14th & Lavaca

Design Commission

Date: April 18, 2023
To: City of Austin Design Commission
From: Planning & Urban Design Working Group
Subject: Density Bonus Working Group review of 14th & Lavaca for substantial compliance with the Urban Design Guidelines
Meeting date: April 12, 2023; 12:00 pm; Virtual Microsoft Teams Meeting
Applicant: Leah M. Bojo- Drenner Group

Capitol View Corridor

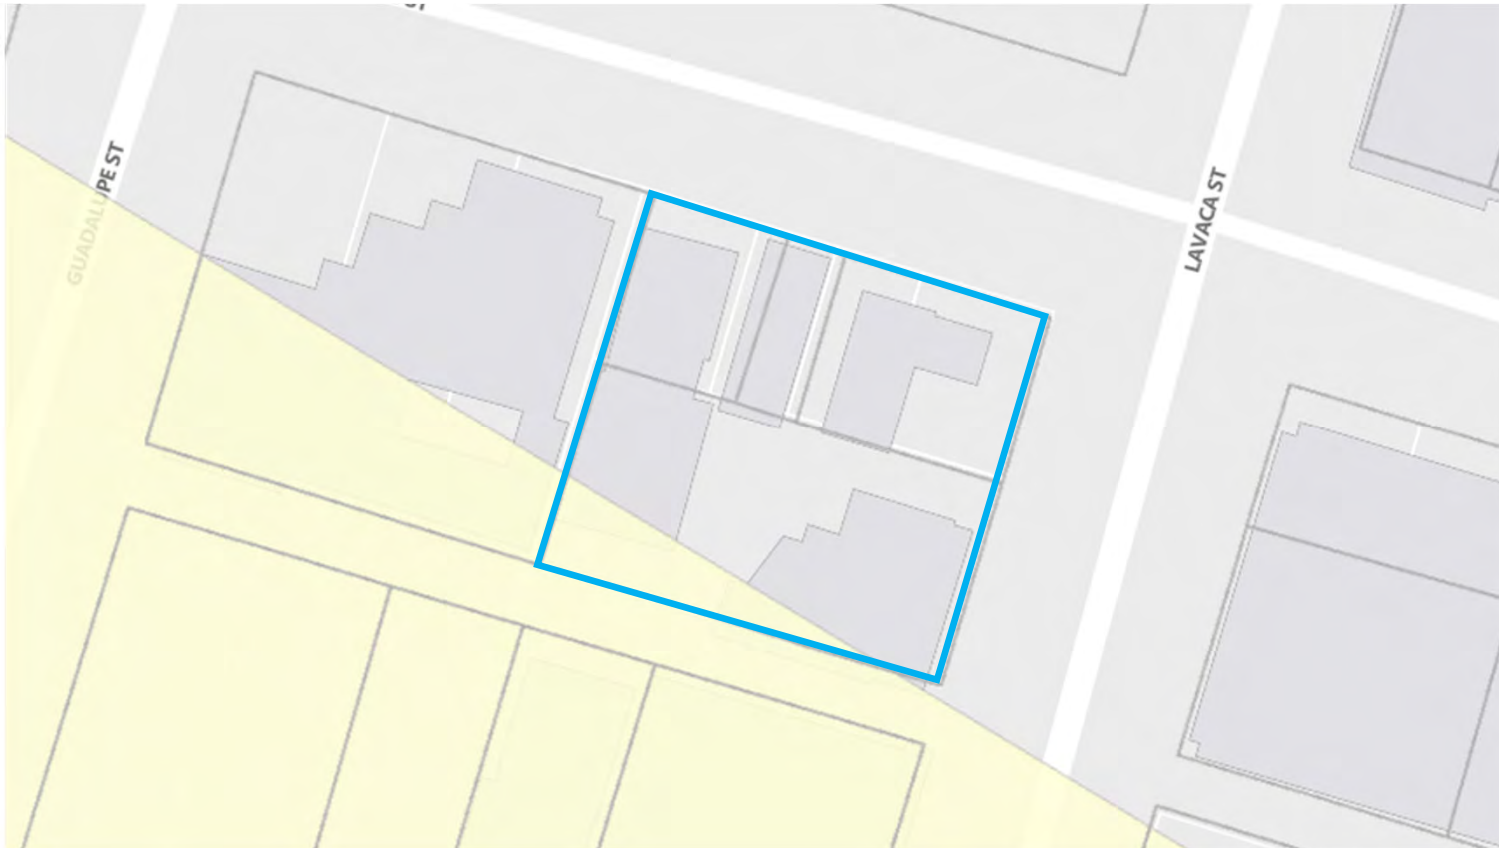
Comment: This project appears to lie within the capital view corridor at the SW corner. Applicant to confirm and indicate location of corridor across the site and how development meets the requirements of this corridor. No other protected / important views appear to be in conflict with the development.
